Staff Report & Recommendation

SUBJECT: HPB23-0592, **624 Collins Avenue.**

An application has been filed requesting a Certificate of Appropriateness for the construction of a 1-story rooftop addition and design modifications to the building.

1923 Photograph

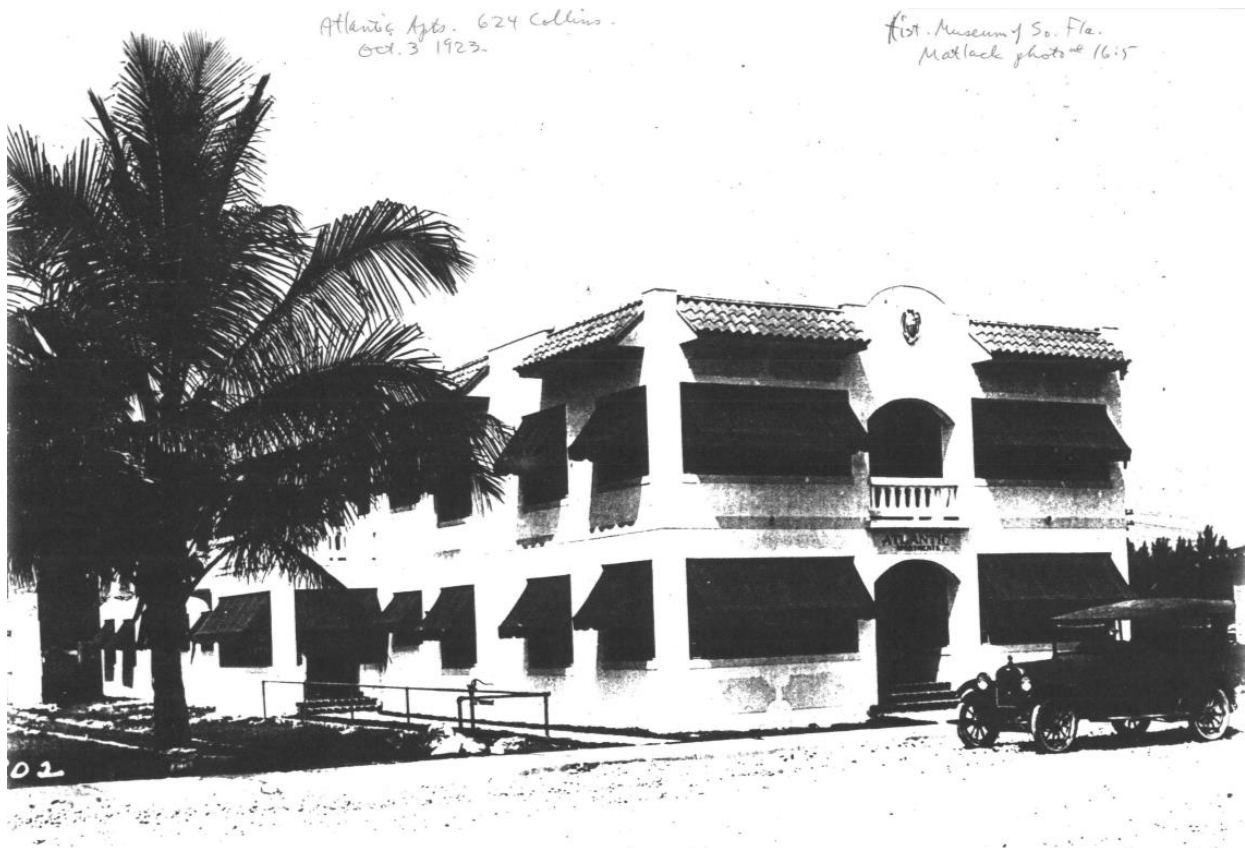
Staff has only two concerns relative to the proposed project. First, in order to address the Sea Level Rise and Resiliency Criteria, staff recommends that the applicant explore raising the lower rear portion of the first-floor level (currently 6.68' NGVD) to match the higher elevation at the front of the building (8.00' NGVD); to make the building less susceptible to the effects of future sea level rise. Second, at the second level of the Collins Avenue façade, the applicant is proposing to enclose the open-air porch including the removal of the existing decorative balustrade. Although the balustrade is not original, it was designed in a manner somewhat consistent with historical documentation. Staff has no objection to the proposed enclosure of the porch with glass but does

recommend that a new balustrade be introduced on the outside of the glass that more closely resembles to the original design in order to maintain the proportions of the primary façade

- b. A new balustrade shall be introduced on the outside of the proposed storefront glass enclosure at the second level along Collins Avenue in a manner consistent with available historic documentation, in a manner to be reviewed and approved by staff consistent with the Certificate of Appropriateness Criteria and/or the directions from the Board.
